FIELD SERVICE BULLETIN

FSB Number: LVCCFSB2005-371
Authors: Darwin Garcia
Date: December 28, 2005
Total No. of Pages: 3
Subject: **V3i Bezel Shorting**
Model Affected: **V3i**
Level of Repair: 2

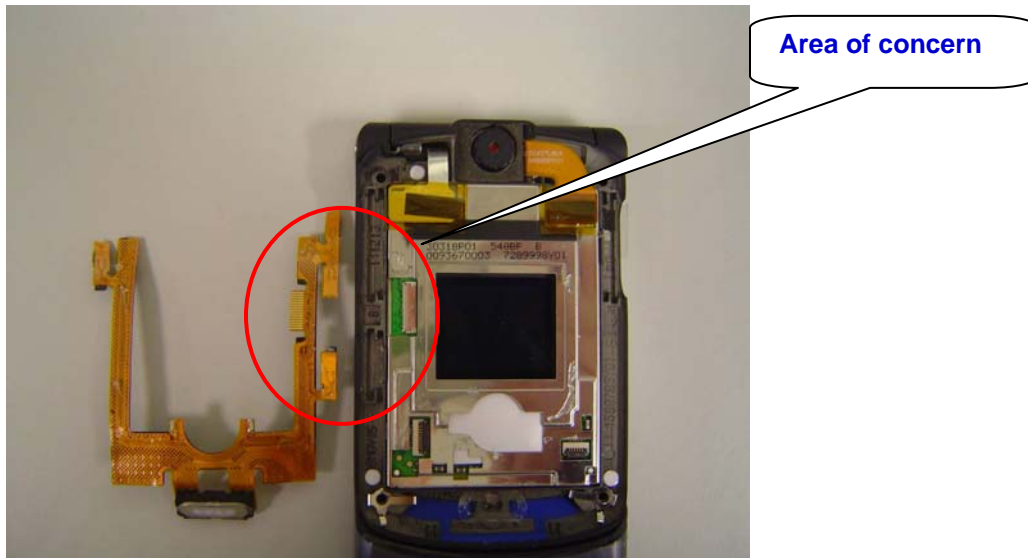
Service has been made aware of a V3i Siliqua Bezel Shorting issue where the M logo and Bluetooth LED will always turn on which could cause “Alert - LED, wrong indicator” complaints. The symptom will show when the SIM cards and the battery are in placed, even without turning on the phone.

The root cause was determined to be P-Flex within flip shorted with metal bezel due to abrasion with burr on bezel.

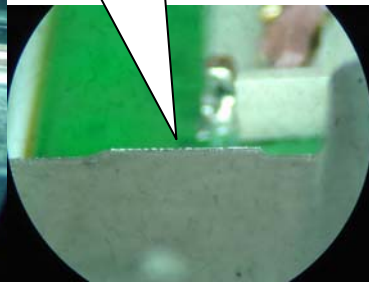
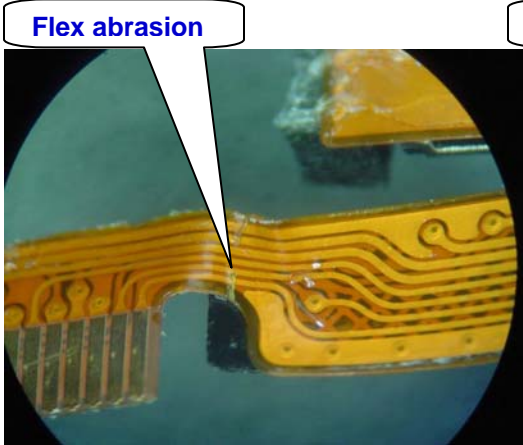
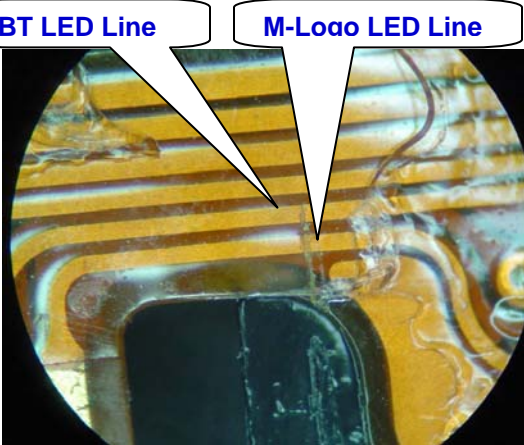
P-Flex sticking to lens and bending sharply at ZIF

Rough bezel

Flex abrasion

BT LED Line

M-Loao LED Line
